SERVICE INFORMATION LETTER NO. T-013

1. SUBJECT: Serialization of Vibration Absorber Beams
2. MODEL: TH-28 and 480
3. EFFECTIVITY: TH-28: Serial Numbers 3004 and 3006
480: Serial Numbers 5001 through 5037
4. BACKGROUND:

FIGURE 1. DATA TAG LOCATION

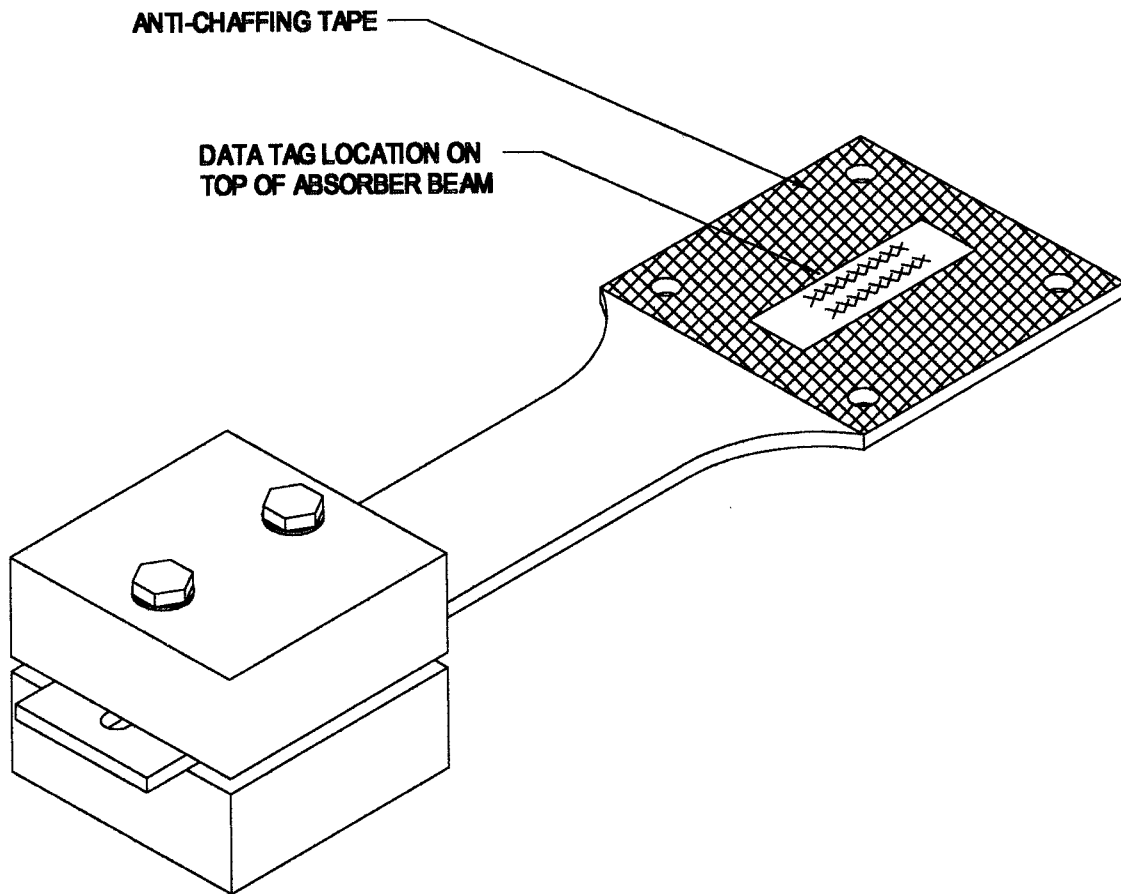
- 5.1.3. Clean the area for the data tag on the beam with isopropyl alcohol and install the data tag (See Figure 1).
- 5.1.4. Reinstall the absorber beam assembly and torque the bolt assemblies to 75 in-lbs (8.5 Nm).
- 5.1.5. Complete the required information on the component record card and insert into the airframe logbook. The component record card must show the time when the vibration absorber beam was actually installed on the aircraft, not the time when this Service Information Letter was complied with.
6. SPECIAL TOOLS: None
7. MAN-HOURS: .5 Manhours
8. WARRANTY: Per Enstrom Warranty Policy
9. WEIGHT CHANGE: None
10. LOG BOOK ENTRY: Enter compliance with this Service Information Letter
11. REPETITIVE INSPECTION: None
